Note

Title	Deadline 4 Noise Responses		
Project	Gatwick Airport DCO		
Reference	28AD.NT.5.0	Author(s)	BHo
Date	30 May 2024	Reviewer	VC

Graph 1: 2032 night-time arrivals split by aircraft type

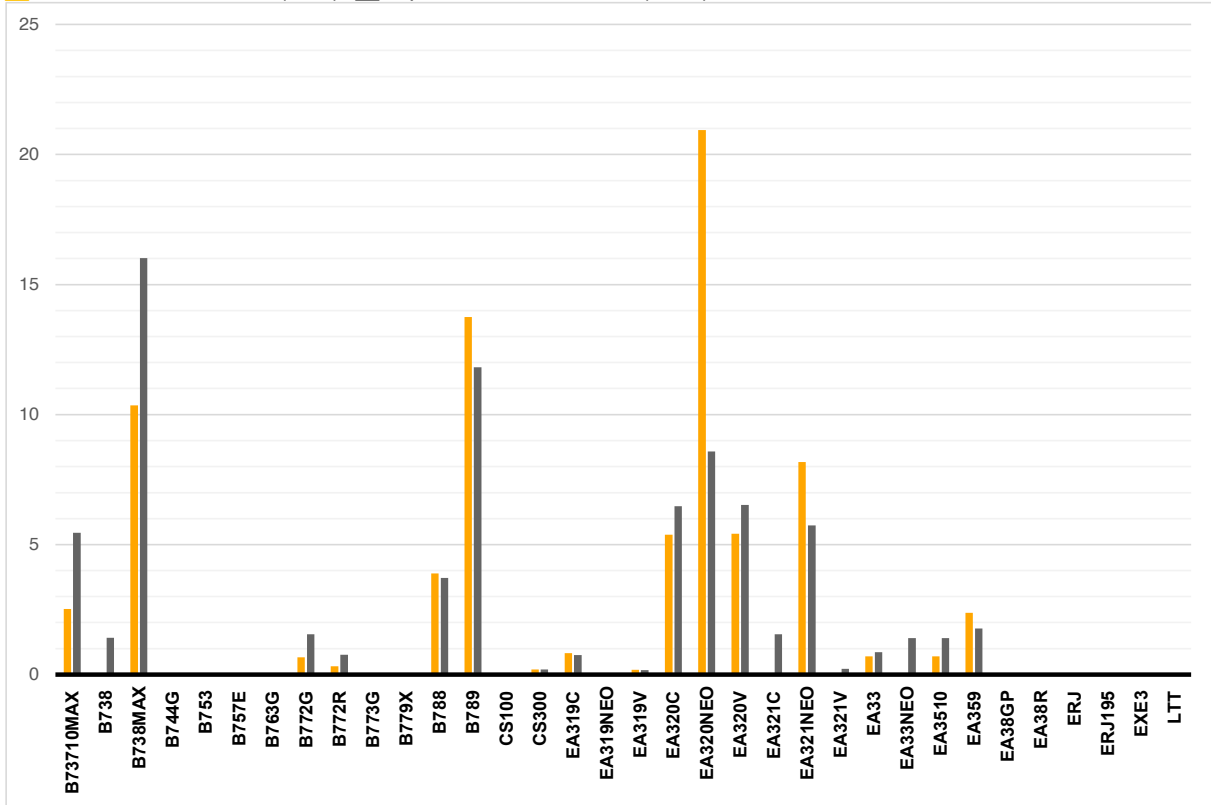
The Applicant appears to be incorrect in the assertion in their second sentence in the above quote that the larger area occurs at night-time as a result of a slower update of next generation aircraft. The assertion is that the UCC contours are larger than the SFT contours as a result of a change in the number of arriving current generation aircraft, with the larger number of noisier aircraft leading to a contour difference.

We have analysed the fleet forecasts provided in REP4-004 and REP3-071 with regards to night-time arrivals for the SFT and the UCC; these can be seen in the two graphs on the page below for 2032 and 2038, respectively.

There are four aircraft types that can be seen to have a material change in the number of arrivals between the SFT and the UCC, these are the Boeing MAX8 and MAX10 (labelled below as B7378MAX and B73710MAX) and the Airbus A320NEO and A321NEO. All four of these aircraft types are unambiguously next generation aircraft. No other aircraft types display any material differences in number of arrivals between the SFT and the UCC, not least any current generation aircraft types. If there is no material change in arrivals of current generation aircraft, then the Applicant's position cannot be correct.
